PERMIT ISSUET

City of Portland, Maine Board of Appeals —ZONING—

Subject: Applic tion for permit for alterations to existing two family dwelling to provide a separate apartment in the third story at 1029 Congress Street

Mr. Joseph Gladu 1029 Congress Street Portland 4, Maine Subject: * plication for permit for raising roof of ell and providing a new apartment in third story of building, making three in all

ARCHITECT Albert R. Farrington 178 Dartmouth St., Portland 5 Maine, Aug. 24, 1948. Mr. Joseph Gladu, 1029 Congress Street. Dear Mr. Gladu,

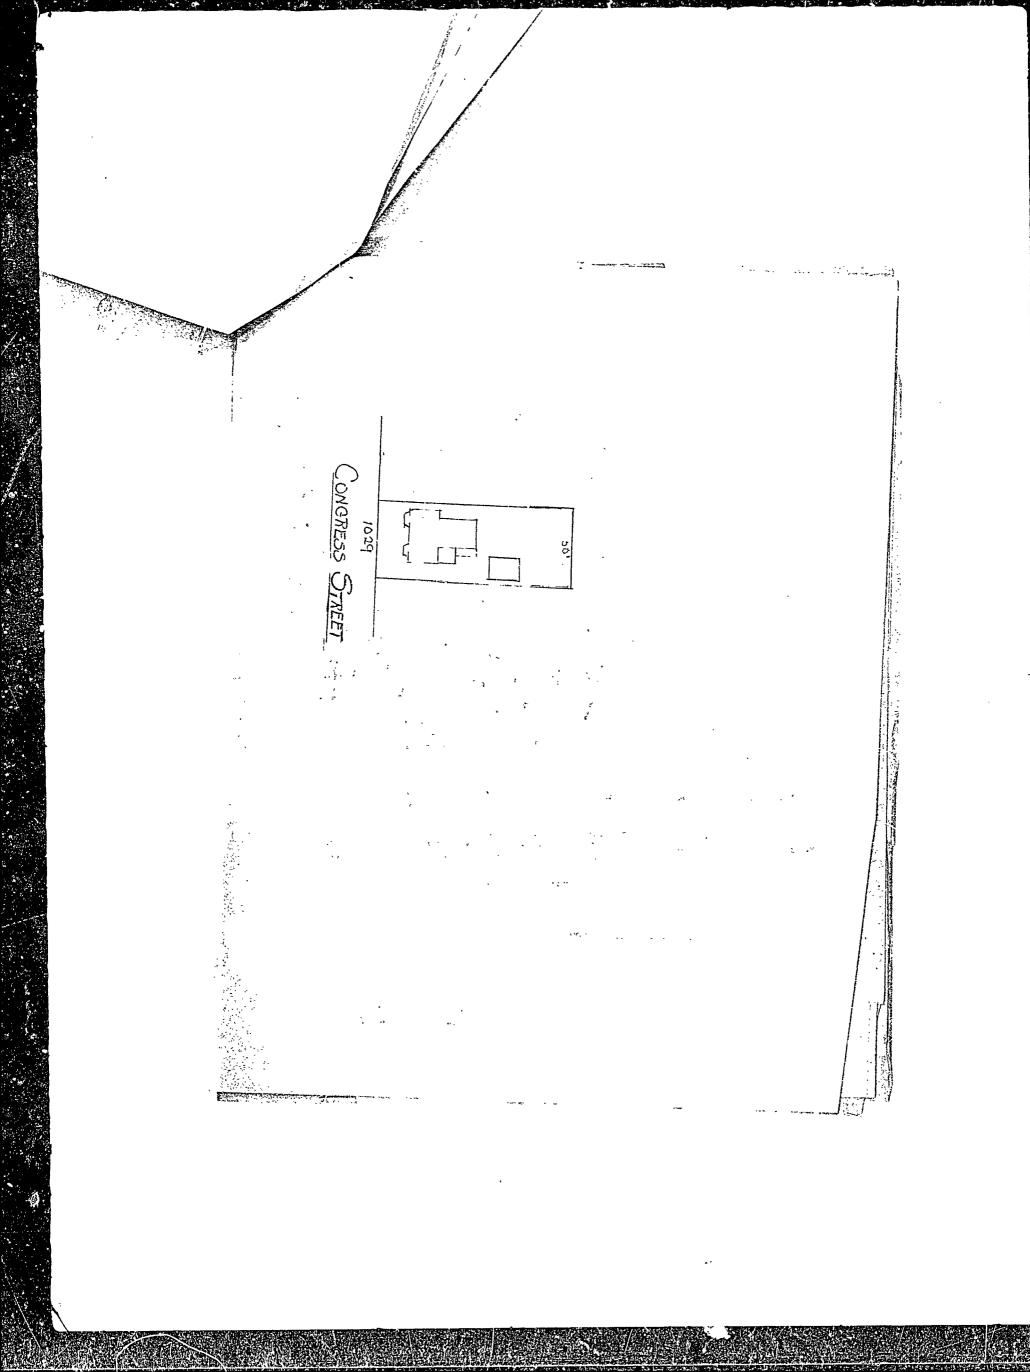
5. What is the rise and tread of new stairs to be and what is to be done about the rather questionable support of the balcony of the new outside stairs where a brace to a single post is shown? / Very truly yours, Wanenny Inspector of Buildings AJS/S CC: Mr. Albert R. Farrington 178 Dartmouth Street

- 6. If not existing, a sound concrete floor is required for the cellar of the building.
- 7. The rise and tread of the new outside stairs is not indicated on the plans. The construction shows for support of the balcony at the second floor level by means of a brace to the 4x6 post seems rather questionable.

The new stairs on the outside of the ell of your house, should be
2½ feet wide. The platform at the top, 2½ feet wide by 3 feet long.

"There should be 3 stringers, 2 by 6, and the blocks cut for 9 inches tread, and rise of not more than 8½ inches, rough cut. The inside stairs shouldhave the same size stringers and blocks. Yours truly. Alberth Farington Copy to Inspector of Buildings. RECEIVED AUG . 1948 DEPT. OF DLD'S. INOP. CITY OF PORTLAND side or the building by turning a single switch near the exit door from his quarters and vice versa, as is required by law. 2. Indication that handrails will be provided on at least one side $\,^{\circ}$ of new stairways and of old ones if not existing. 3. What type of heat is to be provided for the three apartments in the building? 4. Is there a sound concrete floor in the cellar and if not, will one be provided? 5. What is the rise and tread of new stairs to be and what is to be done about the rather questionable support of the balcony of the new outside stairs where a brace to a single post is shown? Very truly yours, Inspector of Buildings AJS/S CC: Mr. Albert R. Farrington 178 Dartmouth Street
